STAFF REPORT AMENDED BY STAFF 12-15-83  
CITY PLANNING COMMISSION

- APPLICATION:
1. Negative Declaration
  2. Tentative Map to divide 31.6± acres into six parcels
  3. Special Permit to develop 224 condominium units known as Gateway Oaks in the Townhouse (R-1A) zone (Zoning Ordinance Section 8-B-3)

LOCATION: West side of Gateway Oaks Drive, north of Garden Highway

PROPOSAL: The applicant is requesting the necessary entitlements to develop 224 condominium units on 14.4 net vacant acres known as Gateway Oaks.

### CONCEPTUAL LANDSCAPE PLAN

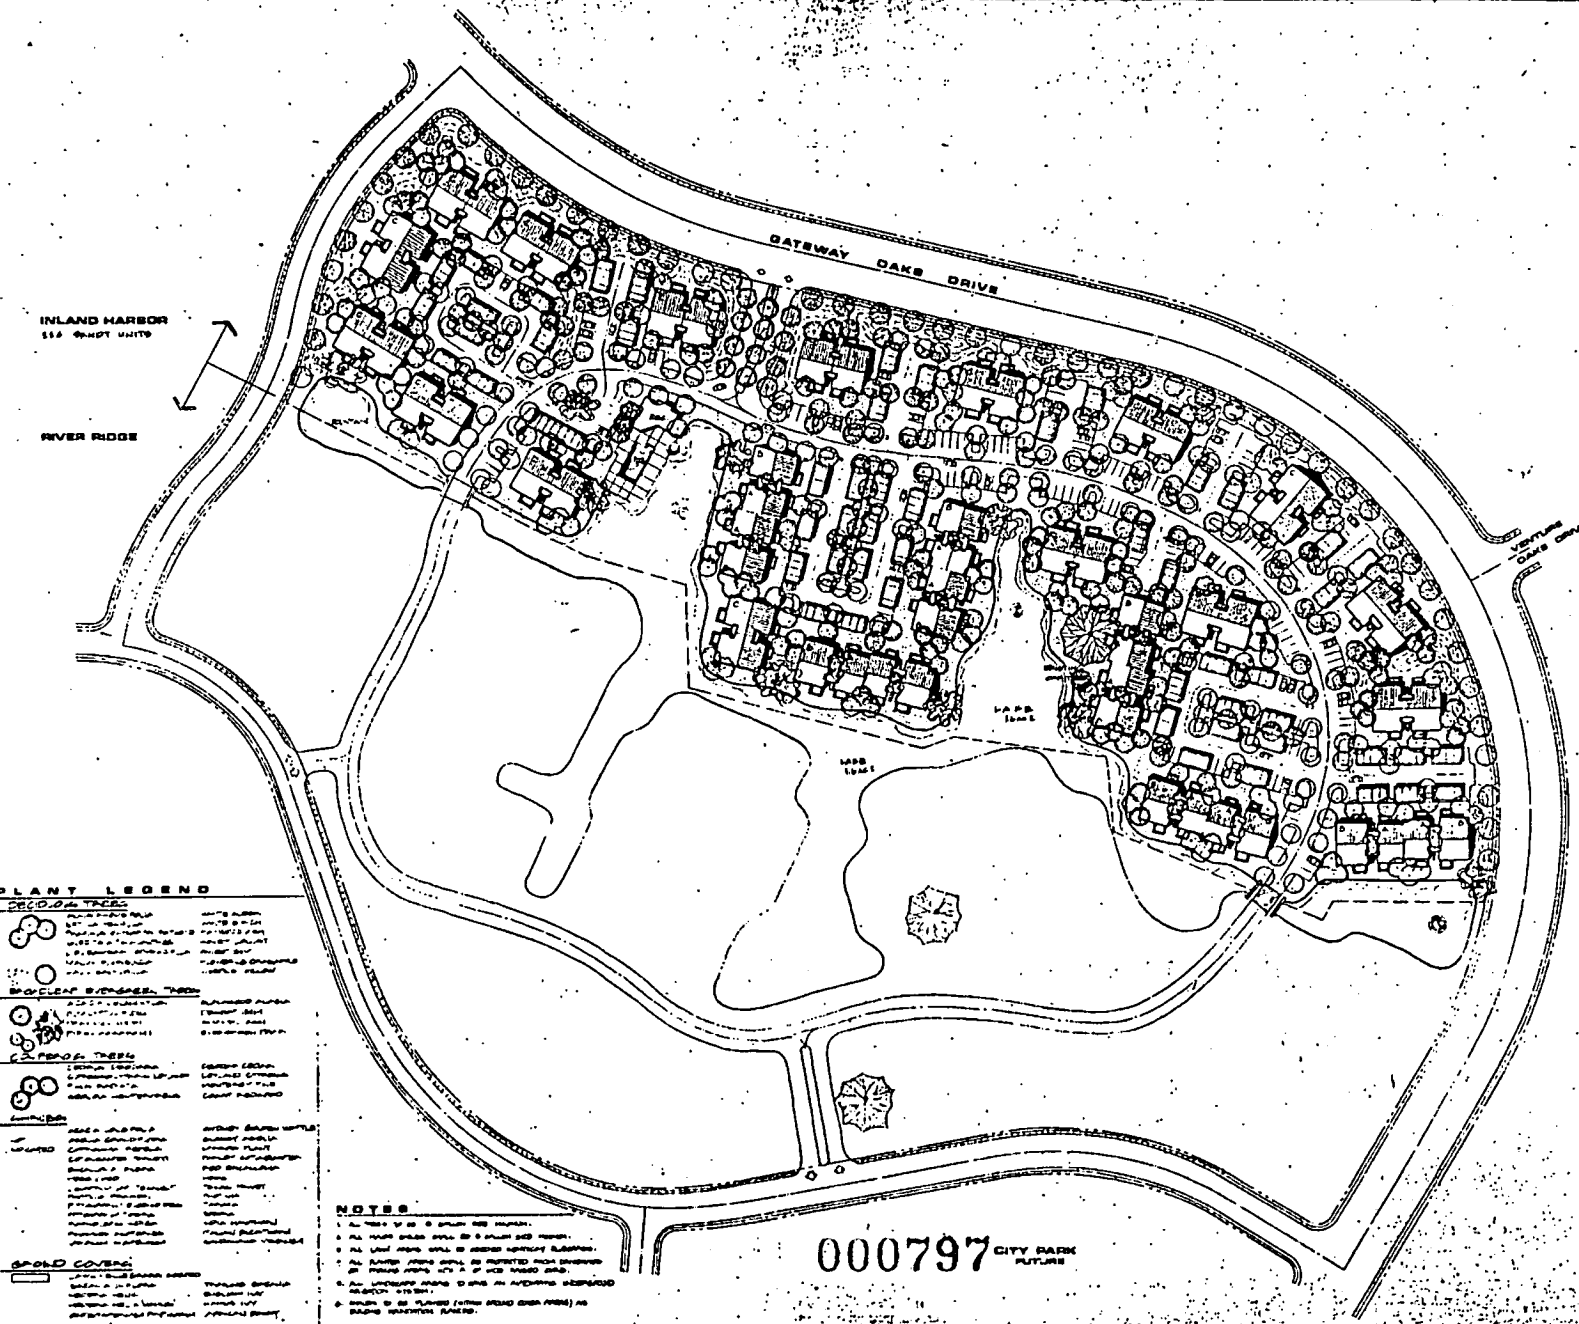
To insure consistency in landscape development throughout the project as well as to insure the incorporation of energy savings design elements and building design and orientation in the site design, staff recommends that Exhibit A be adopted as a condition of approval.

6. The subject site is developed with three large mature Oak trees. The appli-cant's site plan indicates the location of the subject trees and is intended to be incorporated into the project's overall landscape plan. To insure the retention of the three Oak trees, staff recommends that the final map and building permit plans clearly indicate their locations and the necessary notes and conditions be placed on the final map and building plans as a condition of approval.

- c. A detailed landscape and irrigation plan shall be submitted for staff review and approval prior to the issuance of building permits. This plan shall incorporate the design elements as set forth in Exhibit A.

- d. The building permit plans and final map clearly indicate the location of the three Oak trees proposed for retention. No trenching, grading, filling, or other disturbance of the soil within the tree's dripline shall be permitted unless prior approval is obtained from the Planning Director after consultation with the City Arborist.

**TENTATIVE MAP  
GATEWAY OAKS CONDOMINIUMS**

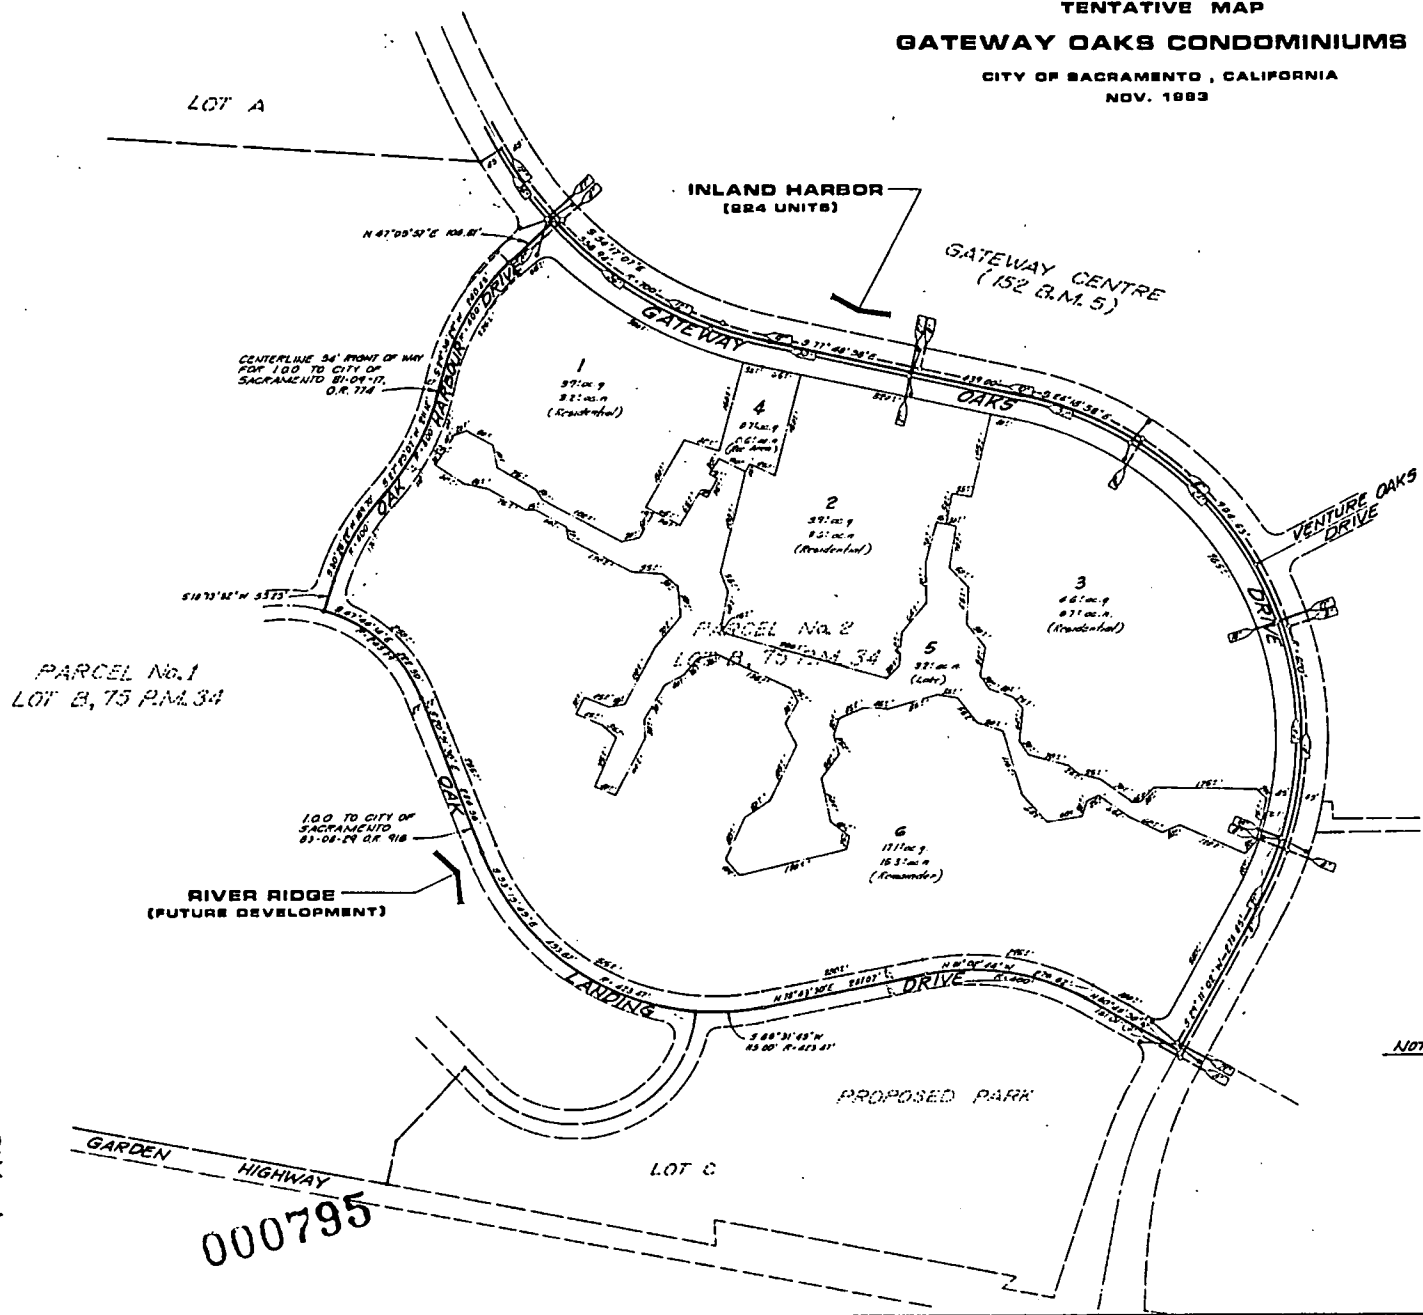
SUBDIVISION REVIEW COMMITTEE RECOMMENDATION: On November 30, 1983, by a vote of seven ayes, two absent, the Subdivision Review Committee recommended approval of the tentative map subject to conditions. The applicant shall satisfy each of the following conditions prior to filing the final map unless a different time for compliance is specifically noted:

1. Provide standard subdivision improvements on all boundary streets as per existing Natomas Oaks 1A plans on file with the City, pursuant to Section 40.811 of the City Code;

3. Pursuant to City Code Section 40.319-1, the applicant shall indicate easements on the final map to allow for the placement of centralized mail delivery units. The specific locations for such easements shall be subject to review and approval of the City Engineer after consultation with the U.S. Postal Service;

4. The applicant/developer shall designate and place on the final map those structures and/or lots which will meet the required eighty percent (80%) south orientation (including solar access) to the satisfaction of the Planning Director;

5. Proposed on-site bridges shall comply with City specifications;
6. Construct driveways to City specifications;
7. The lake area shall be privately maintained. Water supply shall be from private wells. Design of the system shall be approved by the City/County Health Department. A note outlining these conditions shall be placed on the final map;

8. A Homeowner's Association shall be formed and C.C.R.'s developed assigning responsibility of maintenance of the lake area to the Homeowner's Association. C.C. & R.'s shall be approved by the Public Works Director and City Attorney. A note referencing lake maintenance responsibility shall be placed on the final map;

9. Show reciprocal sewer, drainage, water and access easements;
10. Pay off existing assessments;
